UNITED STATES PATENT AND TRADEMARK OFFICE

10/813,228

Office Action Summary	Application No. 10/813,228	Applicant(s) BENEDICT ET AL.	
	Examiner GREGORY W. ADAMS	Art Unit 3652

DETAILED ACTION

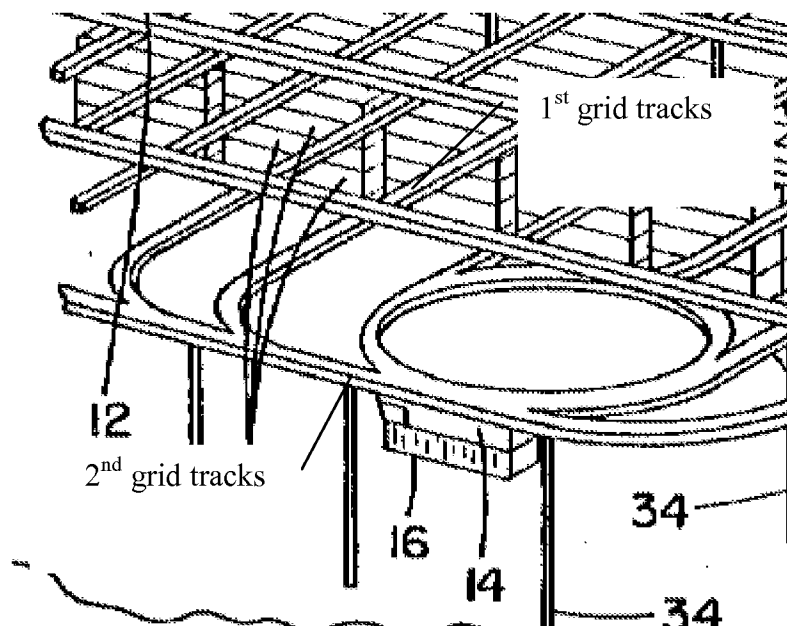
With respect to claims 1, 6 & 21-22, Brickner et al. disclose-

- vertical cells structure 12, 34, 36
- tier levels, e.g. stacked containers 16
- grid track system 12 above vertical cells

- grid first tracks intersecting with second grid tracks (see FIG. 1 reproduced below)
- transfer unit 14 suspended from a grid track system
- a plurality of carriage means (indicated generally as 44) suspending a transfer unit
- transfer unit drive means 54
- spreader beam 40
- hoist means 55
- guide member 42
- means (C18/L30-45) for providing electrical power to a drive means.

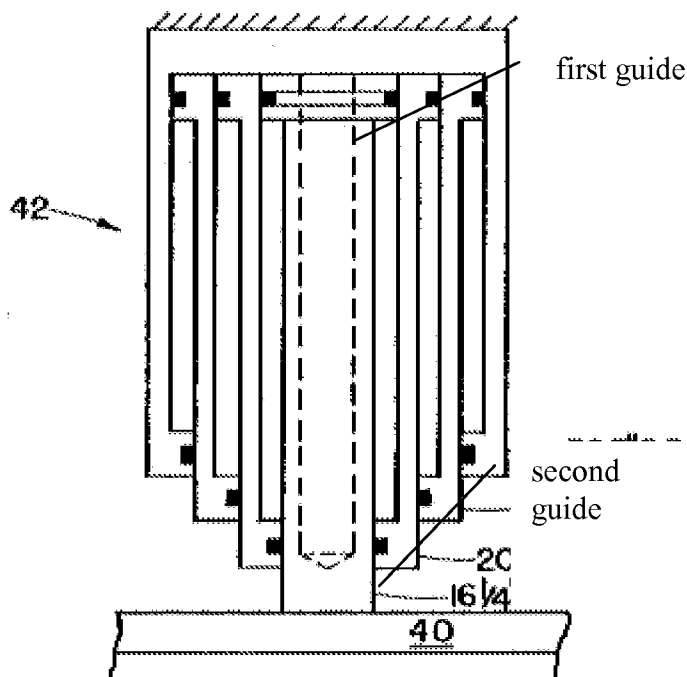
With respect to claims 7 & 18, Brickner et al. disclose a first guide member mounted to a transfer unit and a second guide member mounted to a spreader beam 40 a guide member comprising arms. See FIG. 9 reproduced below.
